Building Permit Application

Permit No.: **B17002572**

MEMORANDUM

RE: B17003380, 12240 Pleasant Springs Ct, propane tank

PLAN VIEW
1" = 50'

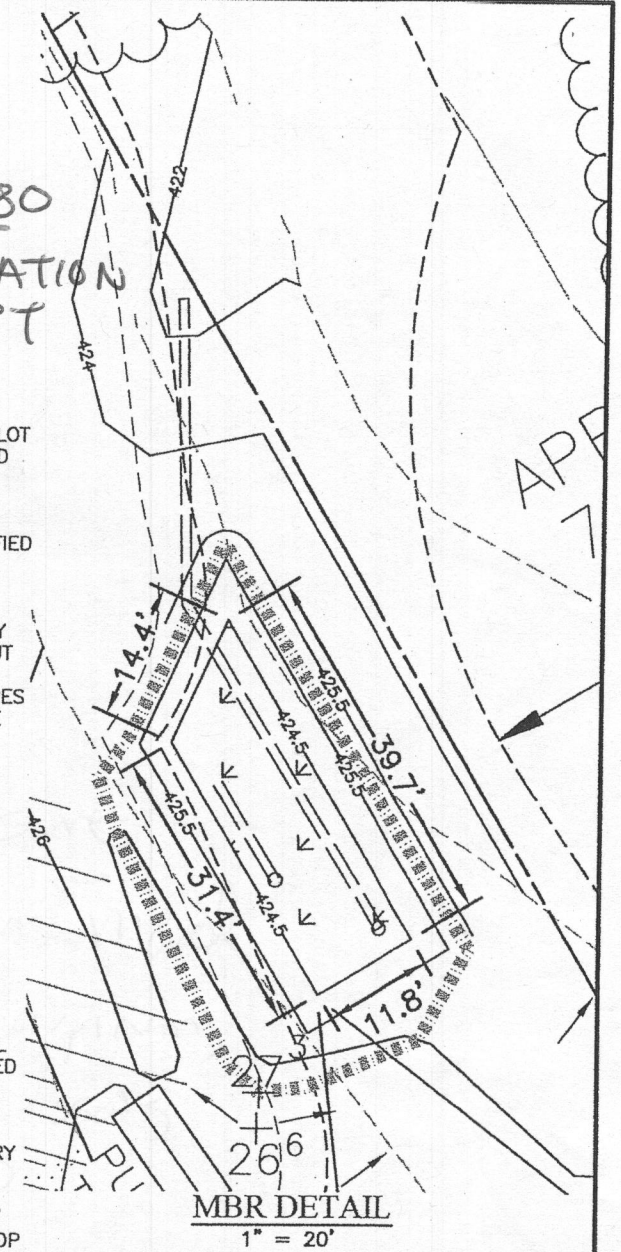
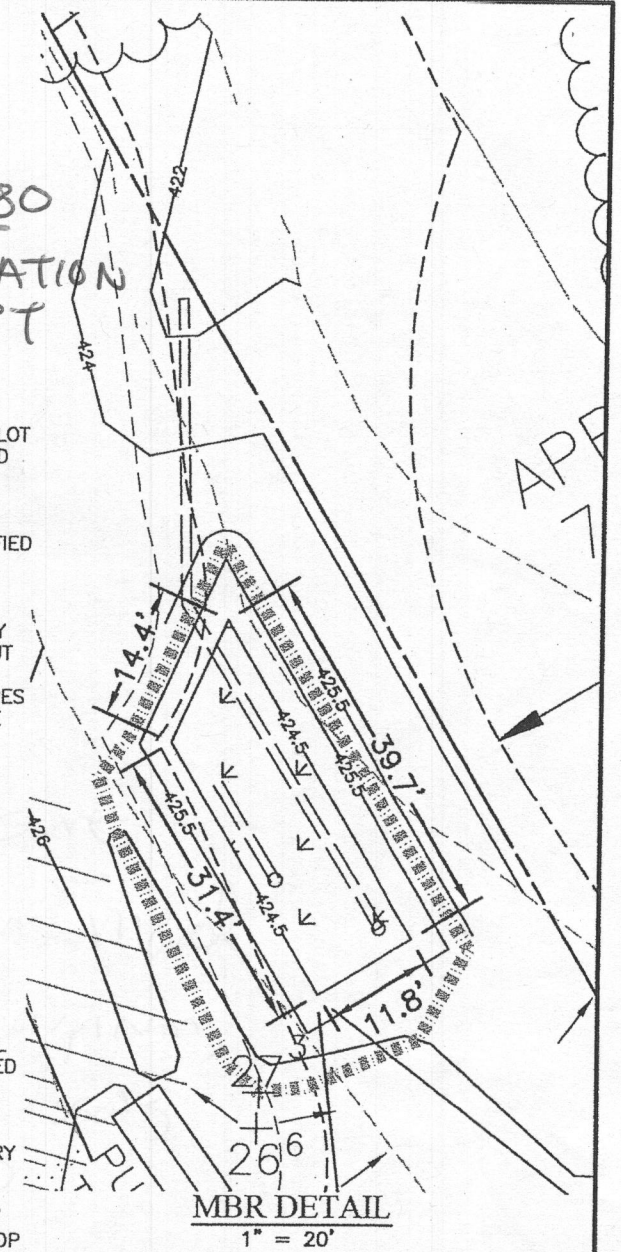
1. The tank location is approximately 2 feet from the well area. The setback from a propane tank to a well and replacement well area is 100 feet. There is a general waiver to allow that distance to be as close as 50 feet.

If an alternate location for the propane tank is proposed, a revised plot plan must be submitted to DILP for review.

REVISED
Date: 11/01/17
Comments: B17003380
CHANGE TANK LOCATION PER HEALTH DEPT

REVISED
Date: 11/01/17
Comments: B17003380
CHANGE TANK LOCATION
PER HEALTH DEPT
